PCB Power Relays G2RL-1 series

Information of Product Code Change according to country origin change.

Effective as of July 1, 2013 (G2RL-1 series)

G2RL-1-E made in JAPAN

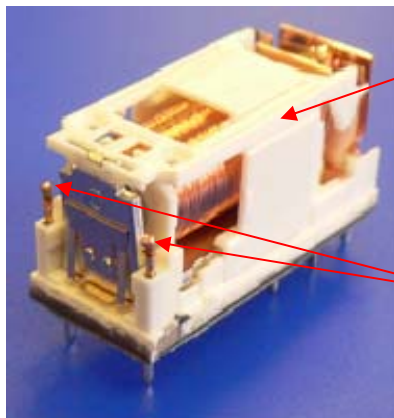
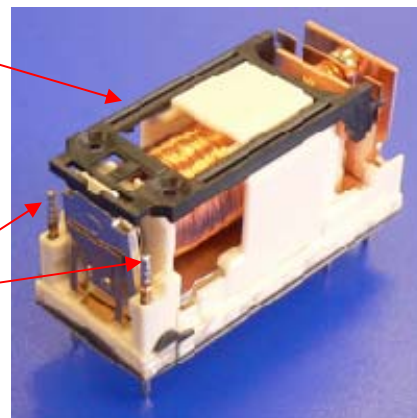
Before the change	After the change
<p>1. Name of production factory OMRON RELAY & DEVICES Corporation (JAPAN)</p> <p>2. Indication of Lot Number ****Y1 (****: Production date Y1: Production factory code)</p> <p>3. Material color in the internal parts (CARD) WHITE [Item A]</p> <p>4. Connection way between magnet wire and coil terminal WELD [Item B]</p>	<p>1. Name of production factory OMRON MALAYSIA SDN. BHD. (MALAYSIA)</p> <p>2. Indication of Lot Number ****W1 (****: Production date W1: Production factory code)</p> <p>3. Material color in the internal parts (CARD) BLACK [Item A] (the same material as Japan)</p> <p>4. Connection way between magnet wire and coil terminal SOLDER (Pb free) [Item B]</p>
